SOUTHERN CALIFORNIA EDISON'S MOORPARK- NEWBURY 66 kV SUBTRANSMISSION LINE PROJECT

CPUC A.13-10-021

Final Environmental Impact Report
(Response to Comments)

Figure 5.7-2
Geotechnical Boring Locations

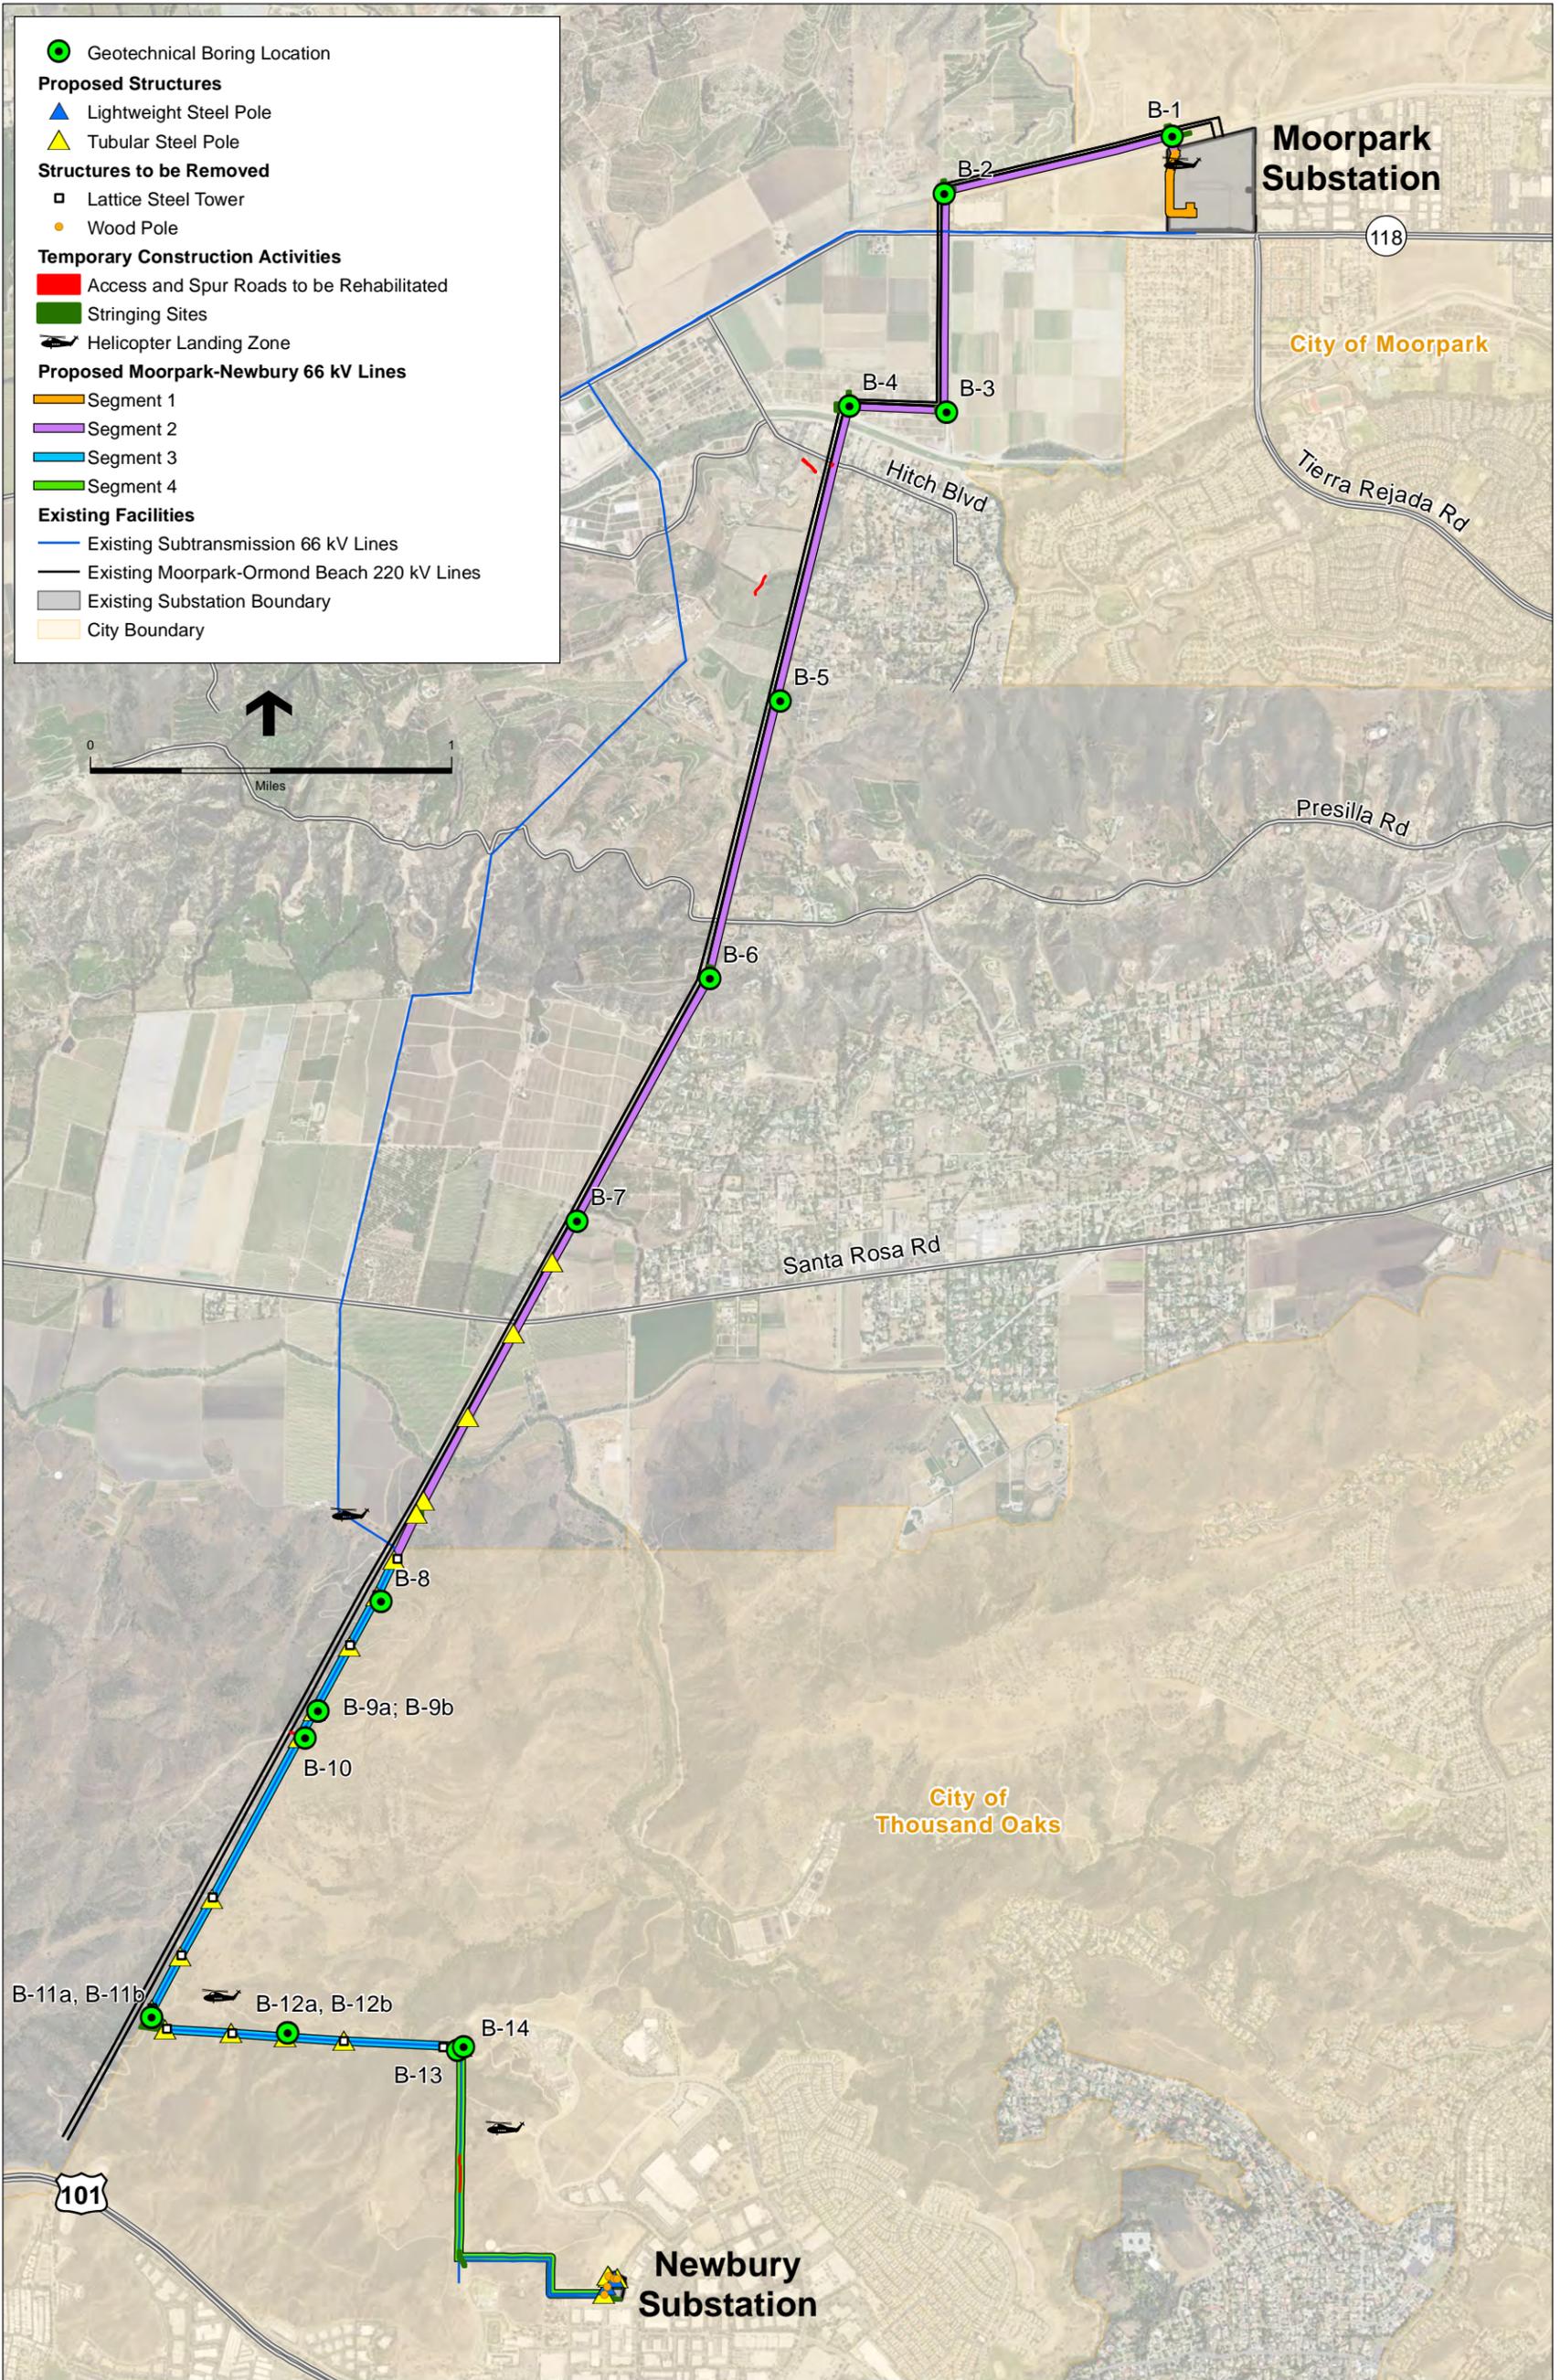
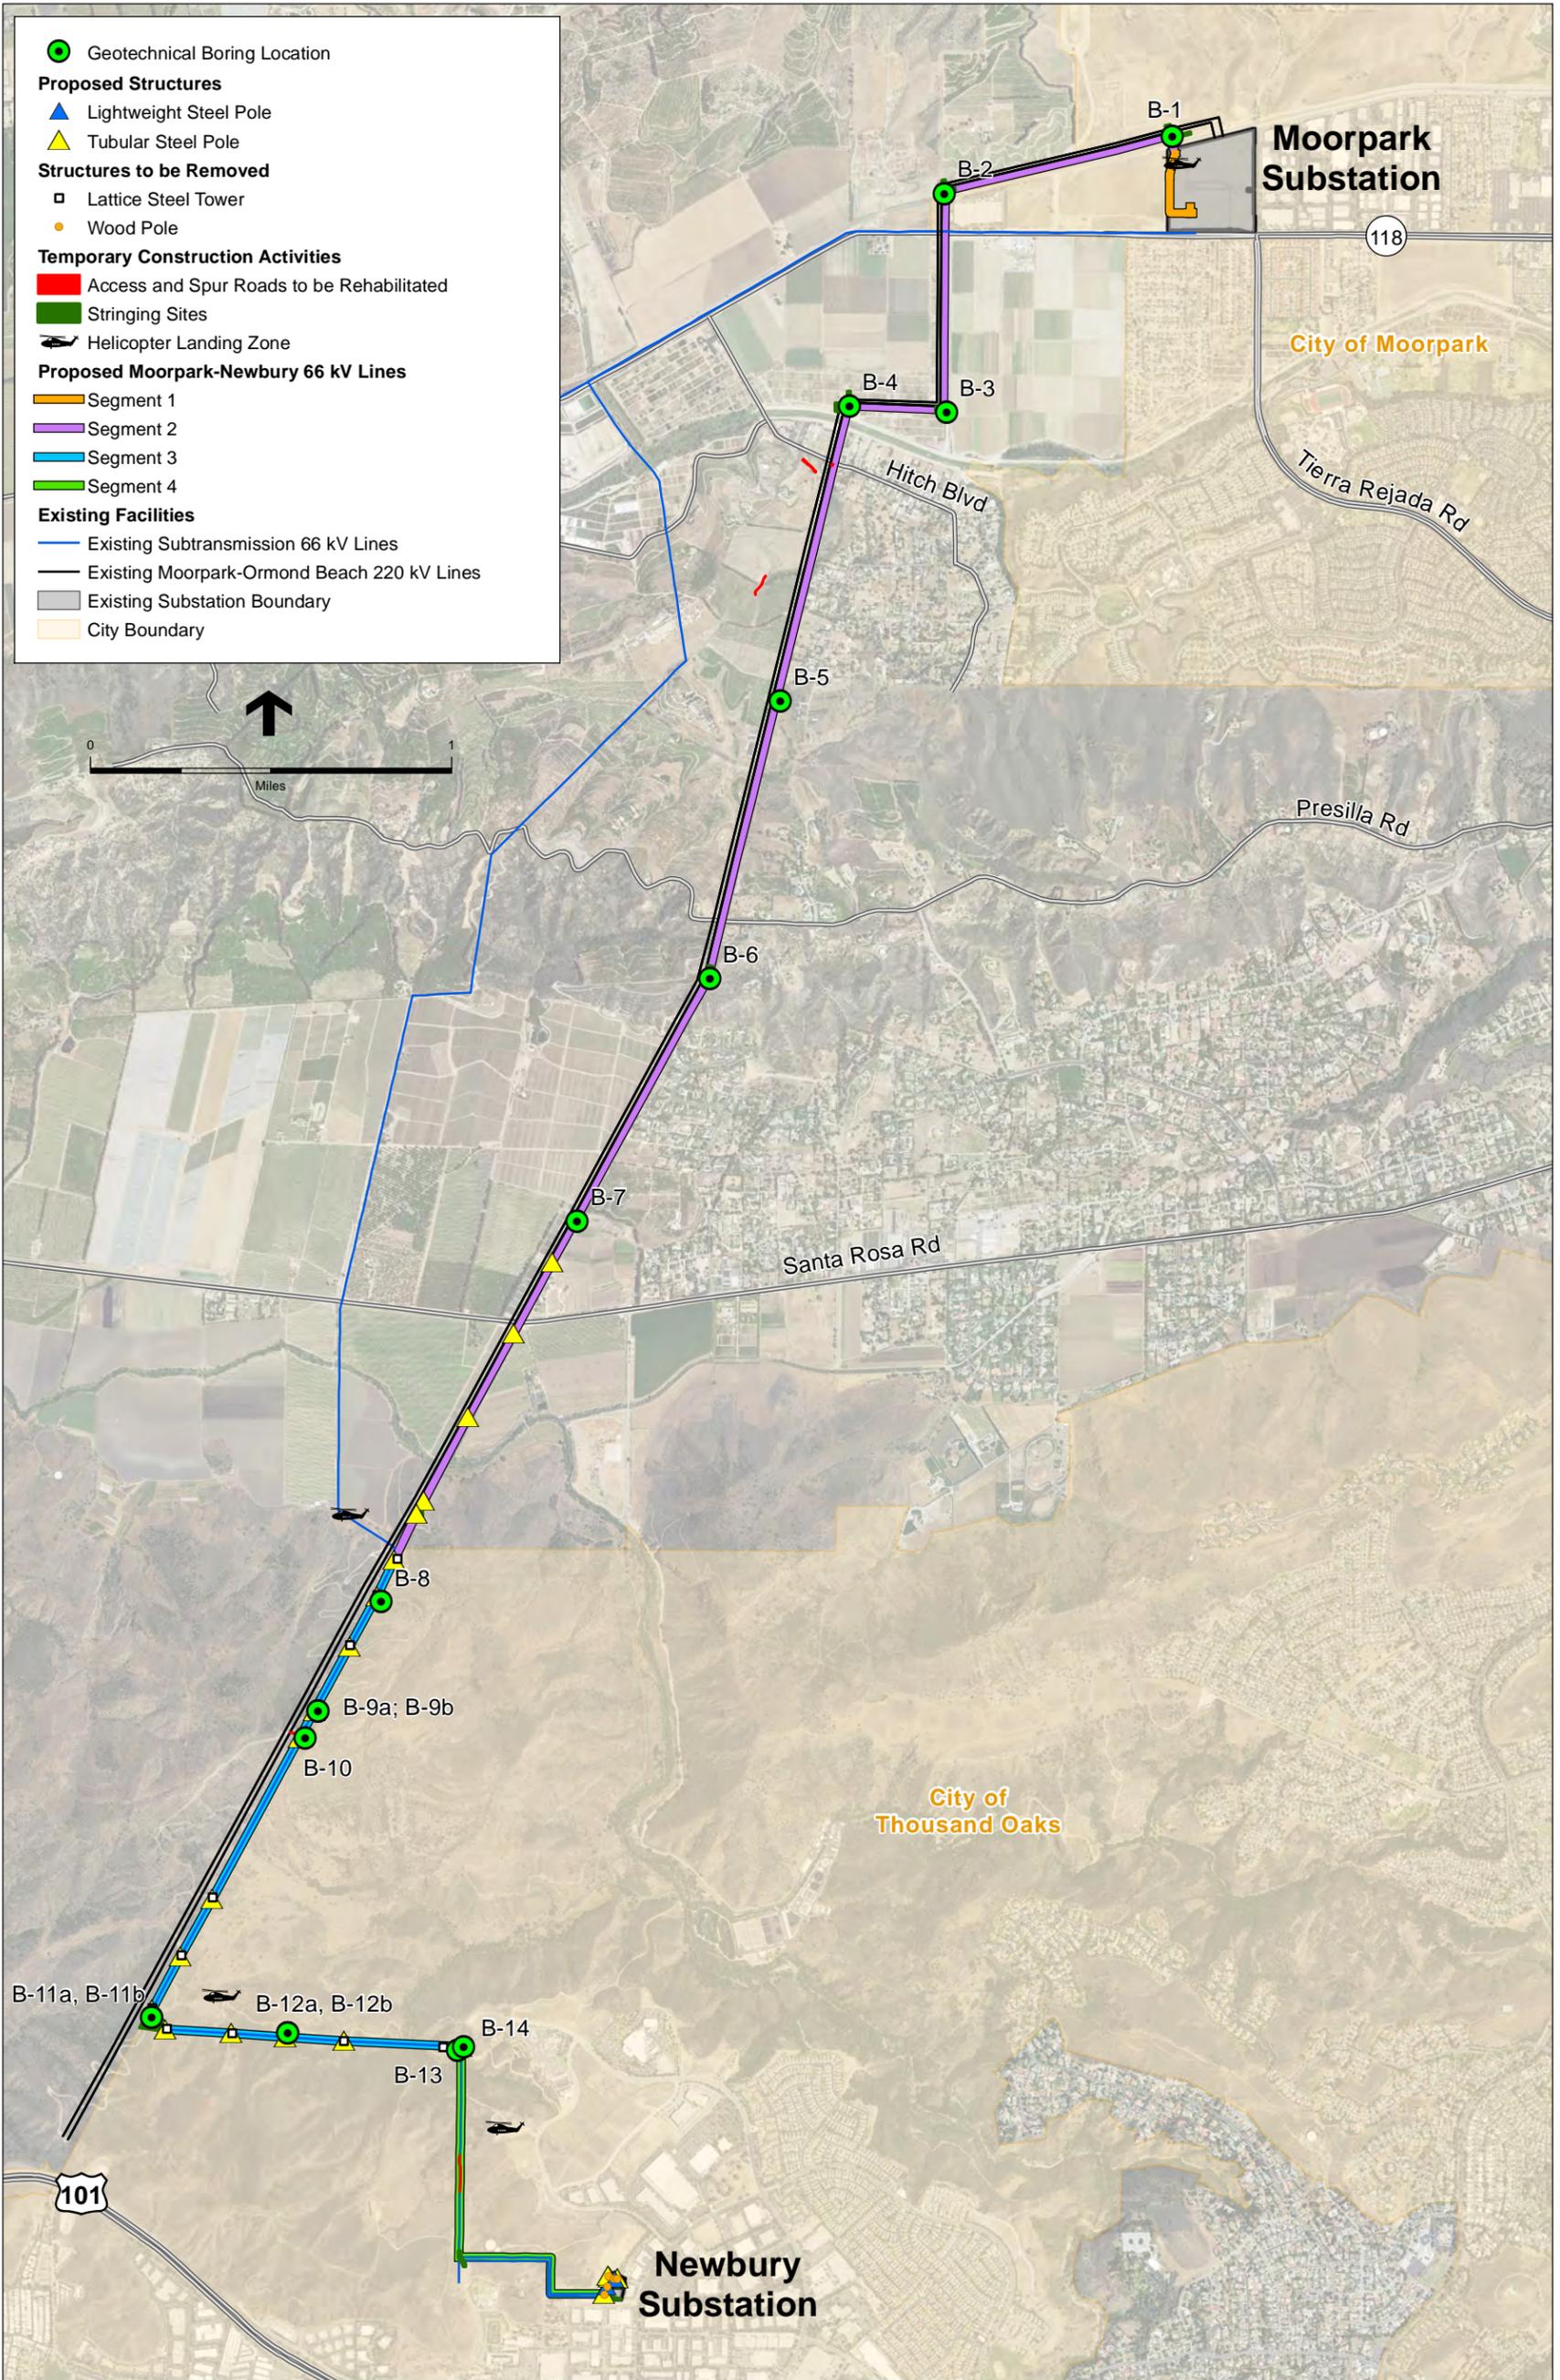
5.7.1	5.7-2	<p>Under the heading Soils, the last sentence of the second paragraph states:</p> <p>“Soil engineering properties were also evaluated at specific boring locations identified in the geotechnical data report prepared for previous construction along the alignment, shown in Figure 5.7-2, <i>Well Boring Locations</i>”</p>	<p>The borings were drilled for geotechnical soil data, not for well installation or construction. Accordingly, please revise as follows:</p> <p>“Soil Engineering properties were also evaluated at specific boring locations identified in the geotechnical data report prepared for previous construction along the alignment, shown in Figure 5.7-2, Well <u>Geotechnical Boring Locations</u>”</p>	O9-43
Figure 5.7-2	5.7-4	<p>The title of Figure 5.7-2 reads:</p> <p>“Figure 5.7.2 Well Boring locations”</p>	<p>The borings were drilled for geotechnical soil data, not for well installation or construction. Accordingly, please revise as follows:</p> <p>“Figure 5.7.2 Well <u>Geotechnical Boring</u> locations”</p>	O9-44

Figure 5.7-2	5.7-4	<p>The legend of Figure 5.7-2 reads:</p> <p>“Figure 5.7.2 Well Boring locations”</p>	<p>The borings were drilled for geotechnical soil data, not for well installation or construction. Accordingly, please revise as follows:</p> <p>“Well <u>Geotechnical Boring</u> locations”</p>	O9-45

O9-44 The title of Draft EIR Figure 5.7-2 on page 5.7-4 has been changed to clarify that borings were drilled for geotechnical soil data, not for well installation. The revised Figure is presented on the follow page.

O9-45 The legend on Figure 5.7-2 on page 5.7-4 has been changed to clarify that borings were drilled for geotechnical soil data, not for well installation. The revised Figure is presented on the follow page.

- 5.7-4** *The title and legend of Draft EIR Figure 5.7-2 on page 5.7-4 has been changed to clarify that borings were drilled for geotechnical soil data, not for well installation. The revised Figure is presented on page 4-25.*
